AUGUST 2019

VICKERY EXTENSION PROJECT SUBMISSIONS REPORT

WHITEHAVEN COAL

Figure 12

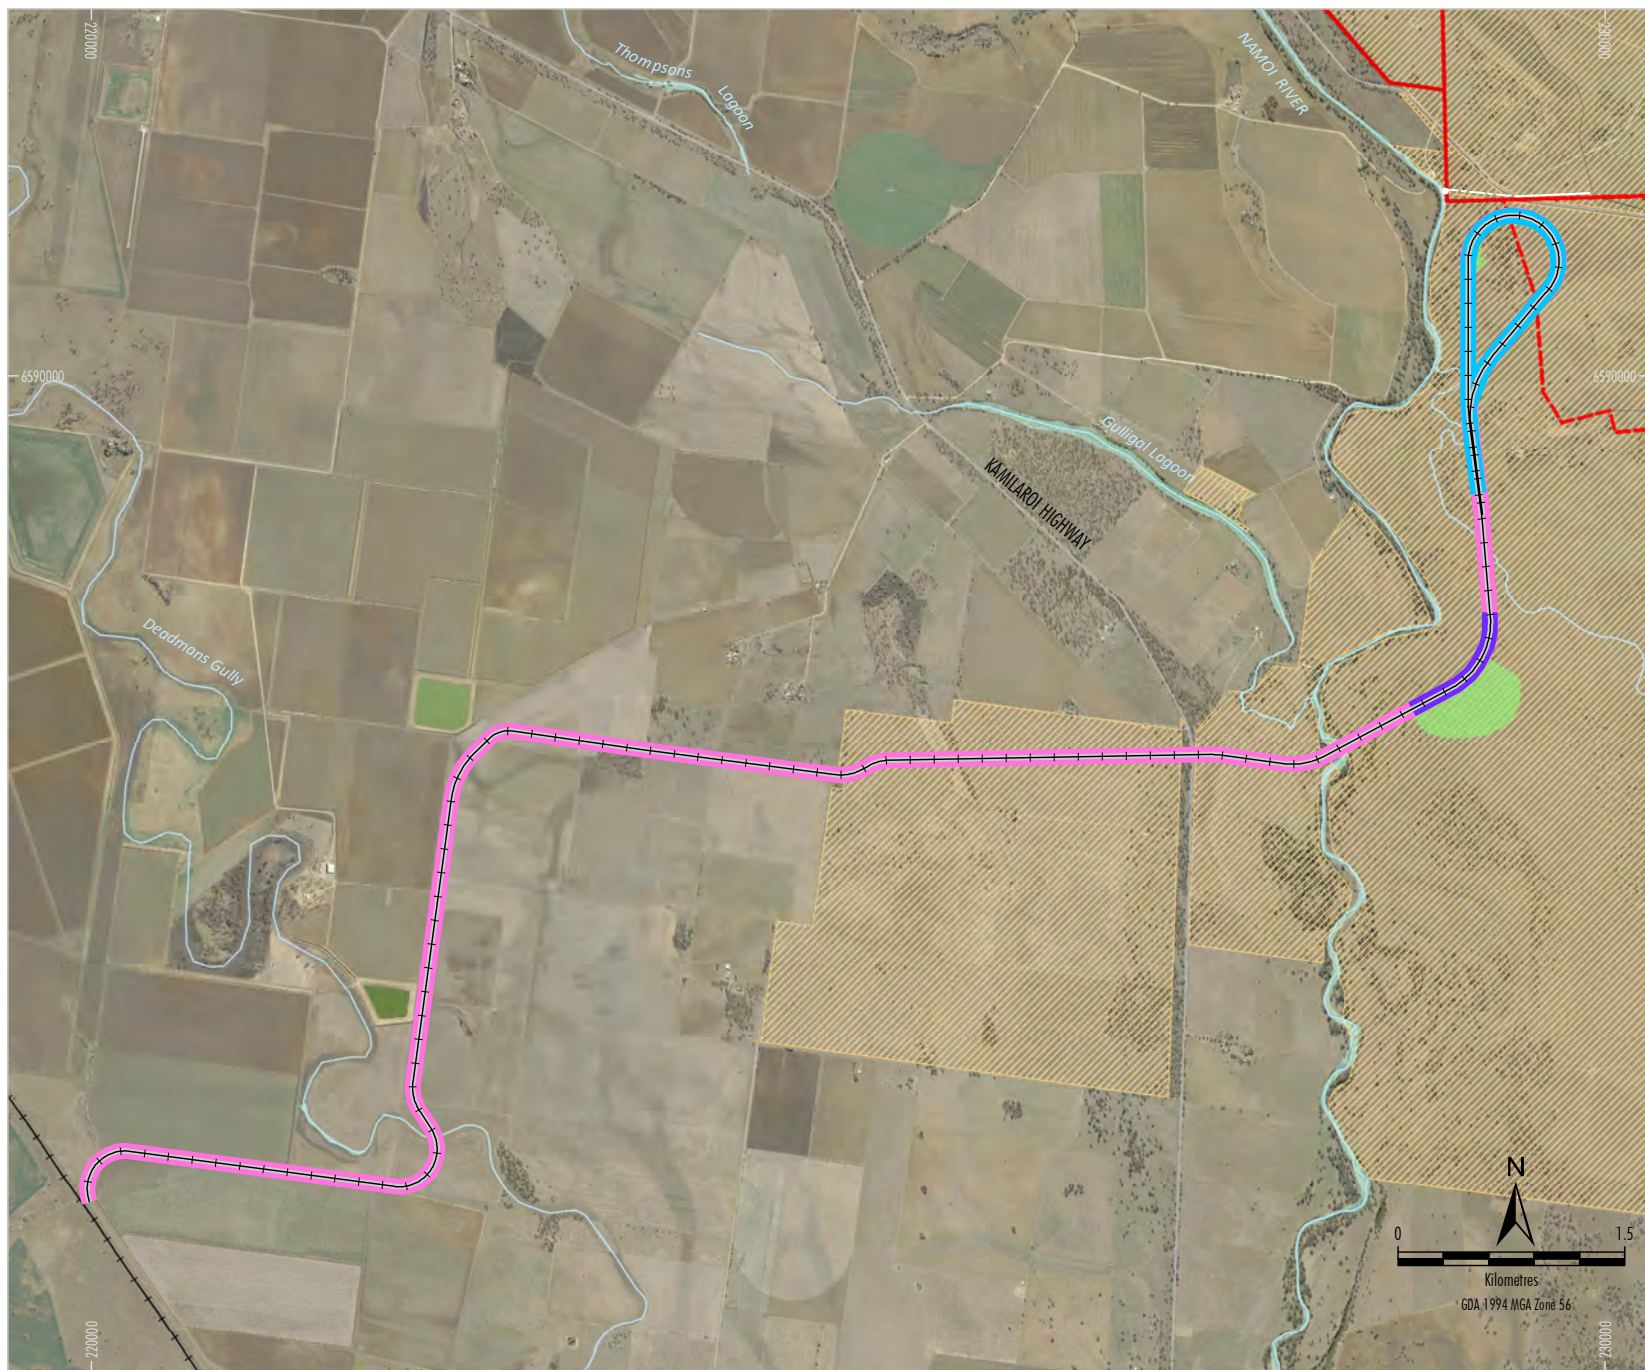
2. Accuracy of flood modelling and predictions

WRM has remodelled the Project rail spur to reflect that it will be completely elevated west of the Namoi River (Figure 12), with associated flood impact reduced in comparison to the presented in the EIS (Figure 11).

Figure 14: Predicted flood velocity change due to Project Rail Spur (1% AEP event)
(Source: WRM Water & Environment, 2018)

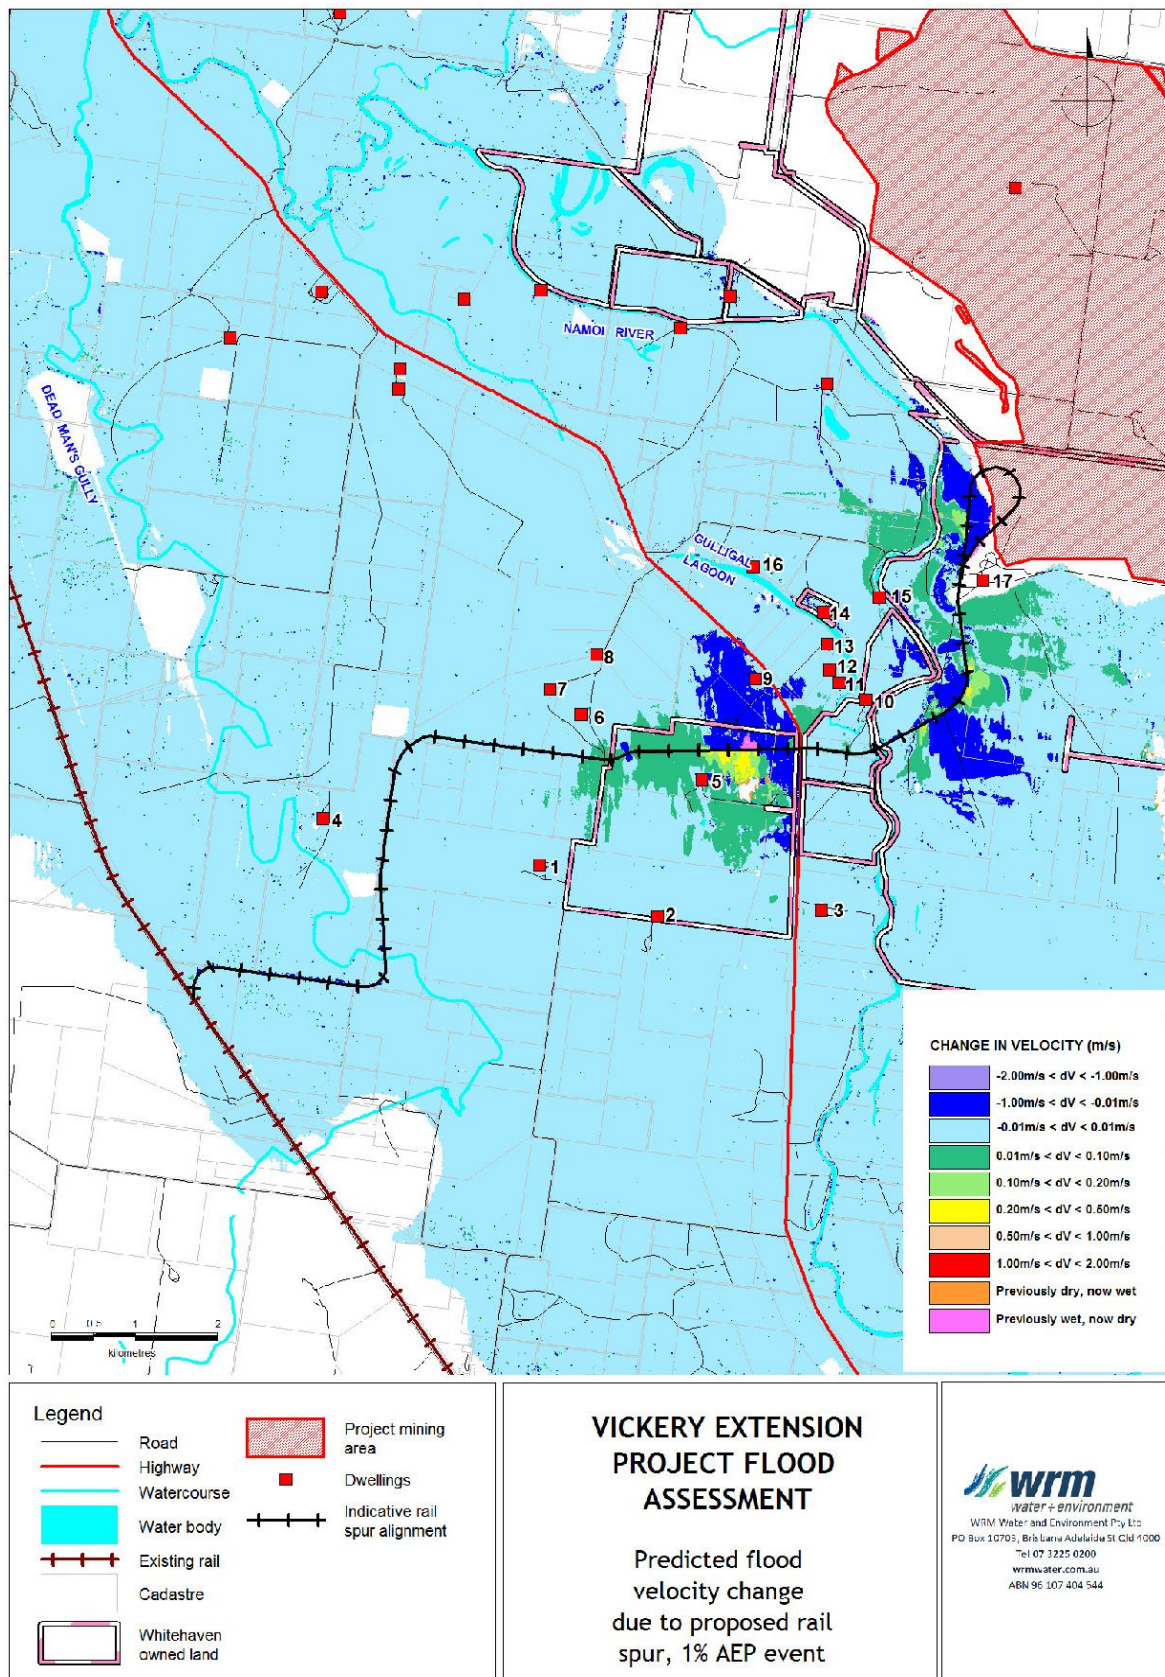
The flood model results predicted an increase in velocity between 0.2 metres per second (m/s) and 0.5 m/s at the ends of embankment sections of the Project rail spur (Figure 6.13 of Appendix C of the EIS, reproduced as Figure 14). The predicted increases on the western side of the Namoi River would effectively be avoided as Whitehaven now proposes to elevate all sections of the Project rail spur west of the Namoi River on piers and/or pylons.

Figure 22: Mine Infrastructure Area Relocation – Scenario 1a (Source: Whitehaven)

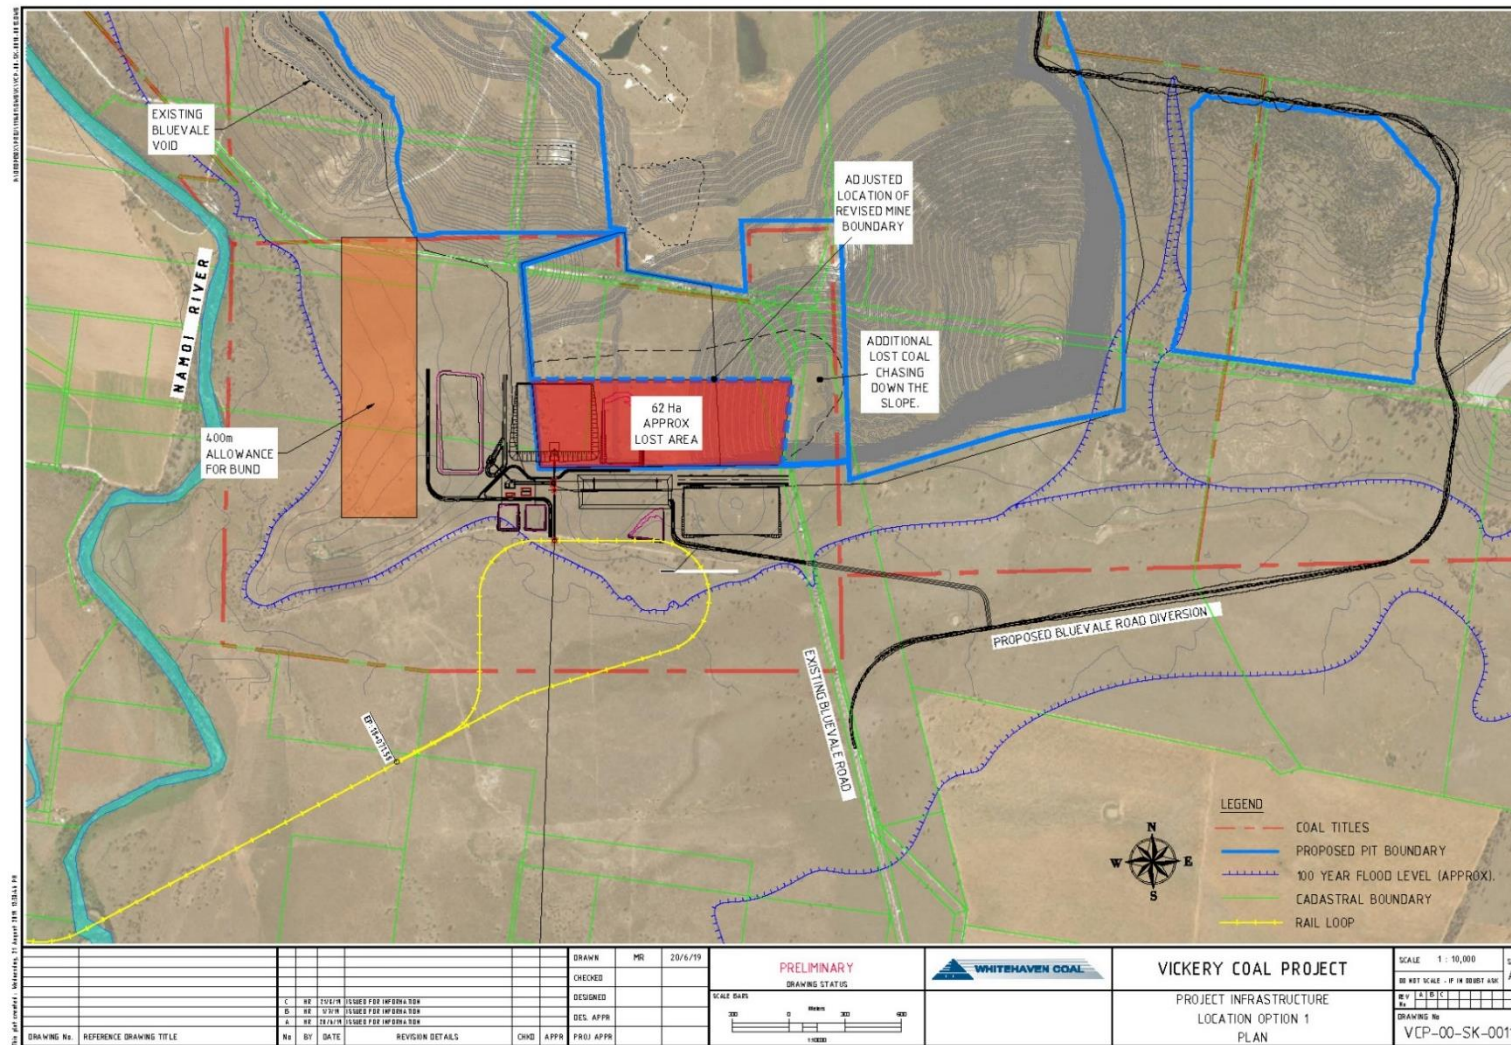
It is noted the IPC acknowledged in their Issues Report that "bunding of the CHPP appears to be problematic due to the required width of the bund to ensure the stability of the bund and potential to sterilise coal resources".

Figure 24: Mine Infrastructure Area Relocation – Scenario 2 (Source: Whitehaven)

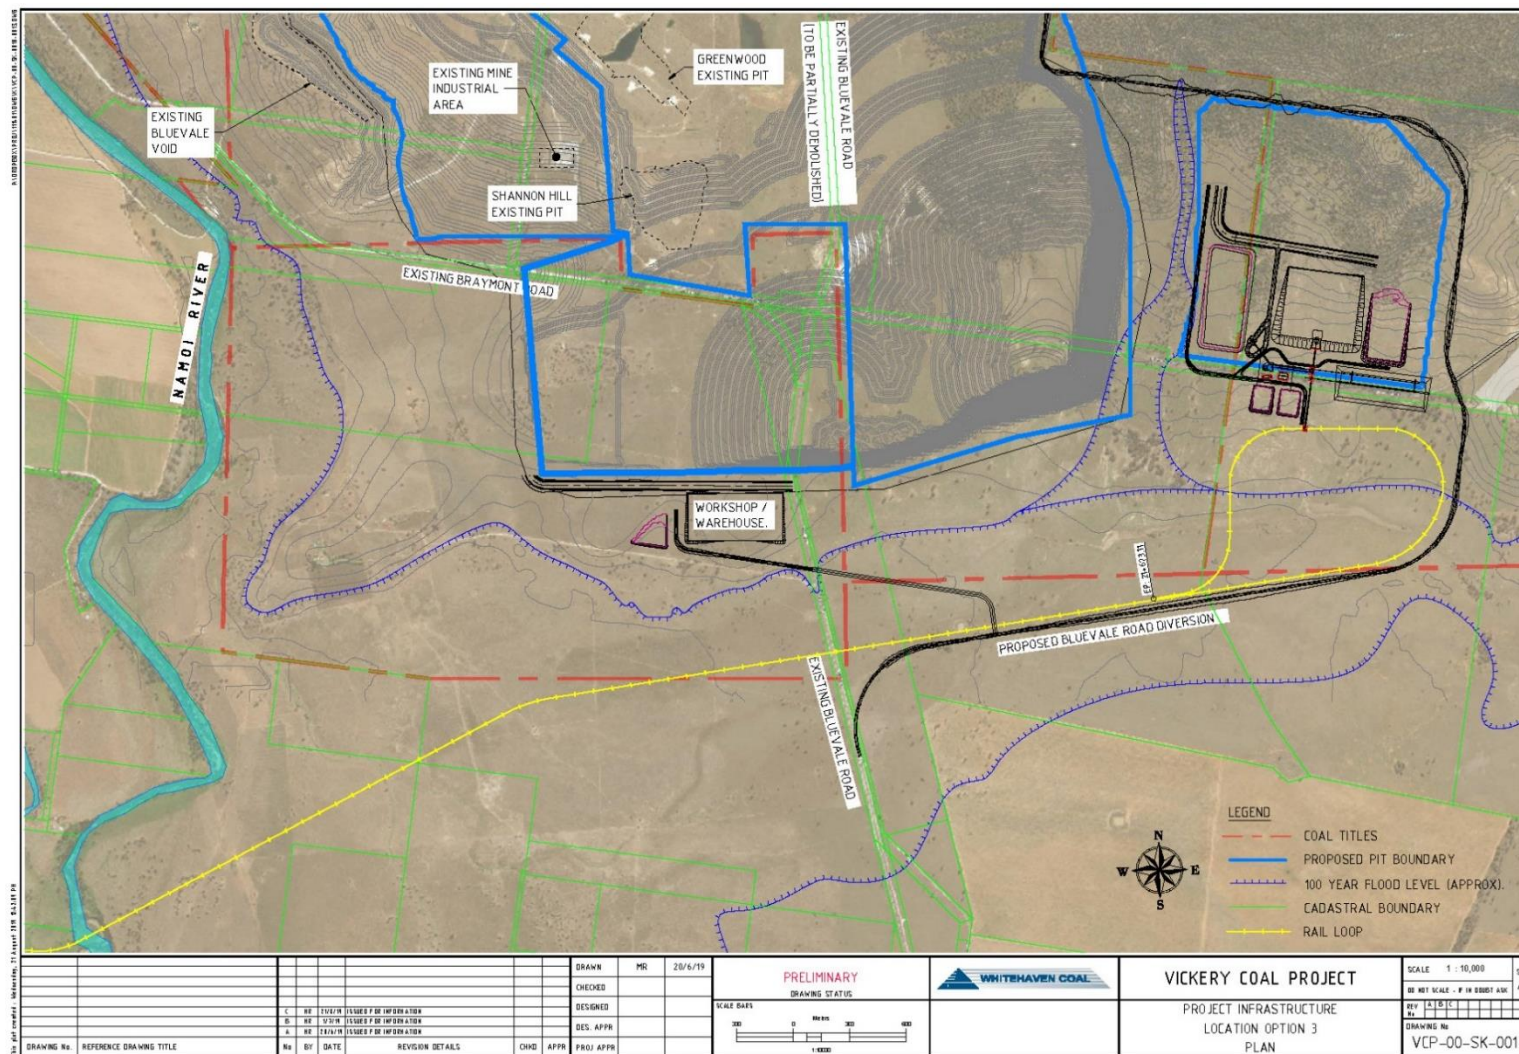
A comparative analysis was undertaken of the proposed mine infrastructure area with the alternate scenario of the infrastructure relocated to the south-east (i.e. within the secondary infrastructure area) (Figure 24).

- partial cladding of the CPP using HushClad acoustic lining or equivalent (e.g. openings for personnel to be retained);
- partial cladding of the ROM bin using HushClad acoustic lining or equivalent (e.g. openings for ROM coal transfer to be retained); and
- covers and/or cladding of conveyors.
